Access Compliance Report

Public Rights-of-Way

Intersection ID: 50100	Main Street: PECAN_FLATS_DR	Cross Street: SUNRISE_VIEW_DR	Location: SW
ADA ID: 8E86C6052E7D	Ramp Type: BlendTrans1	Initial Pass/Fail: Fail	Overall Compliance: No
Severity Score: 8.75			
Codes/Mitigation Info/Possible Solution		Field Measurements/Component Compliance

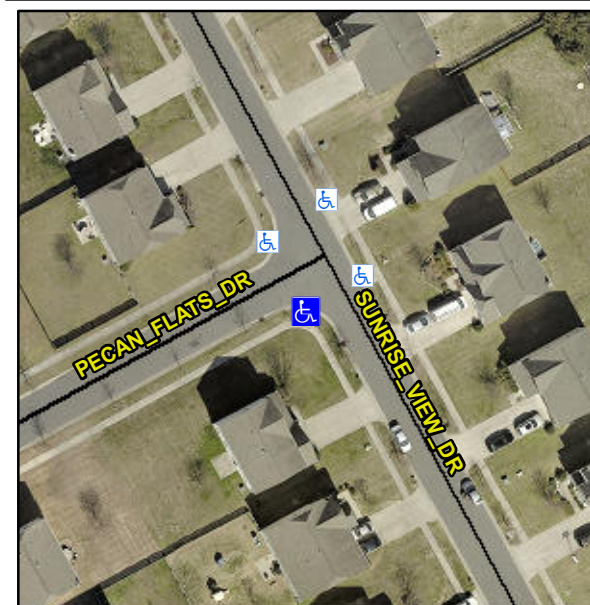
Not Found, R304.5.1

Compliance	Description	Data	Compliance	Description	Data
N/A	Ramp Length (in)	71.0	Yes	BlendTrans Slope (%)	4.4
No	Ramp Width (in)	47.0	Yes	BlendTrans XSlope (%)	1.8
N/A	Flare Type LT	N/A	N/A	Flare Type RT	N/A
N/A	Flare Slope LT (%)	N/A	N/A	Flare Slope RT (%)	N/A
N/A	Flare Traversable LT?	N/A	N/A	Flare Traversable RT?	N/A
N/A	Landing Length (in)	N/A	N/A	DWS Provided?	N/A
N/A	Landing Width (in)	N/A	N/A	DWS Contrast?	N/A
N/A	Landing Slope (%)	N/A	N/A	DWS Length (in)	N/A
N/A	Landing X Slope (%)	N/A	N/A	DWS Full Width?	N/A
N/A	Landing Curb? (Y/N)	N/A	N/A	DWS Offset (in)	N/A
N/A	Shared Landing?	N/A			
N/A	Gutter Ponding?	N/A	N/A	Gutter Slope (%)	N/A
N/A	Gutter Lip Ht (in)	N/A	N/A	Gutter X Slope (%)	N/A
N/A	Painted X Walk1?	No	N/A	Painted X Walk2?	No
	X Walk 1 Direction	To NE		X Walk 2 Direction	To NW
	X Walk 1 Width (in)	N/A		X Walk 2 Width (in)	N/A
	X Walk 1 Slope (%)	0.8		X Walk 2 Slope (%)	0.1
	X Walk 1 X Slope (%)	0.1		X Walk 2 X Slope (%)	1.5

N/A	Ramp inside XWalk1?	N/A	N/A	Ramp inside XWalk2?	N/A
	Road Slope (%)	0.7		Clear Space?	N/A
	Road X Slope (%)	1.4	N/A	Clear Space to XWalk (in)	N/A
N/A	Any Obstructions?	N/A	N/A	Storm Grate/Utility Hazard?	N/A
	Obstruction Type			Storm Grate/Utility Type	
		N/A			N/A
			Yes	Surface Condition? (G/P)	Good
			No	Curb Slope (%)	11.9

Remove & Replace Curb Ramp With Two New Directional Ramps or Equivalent.
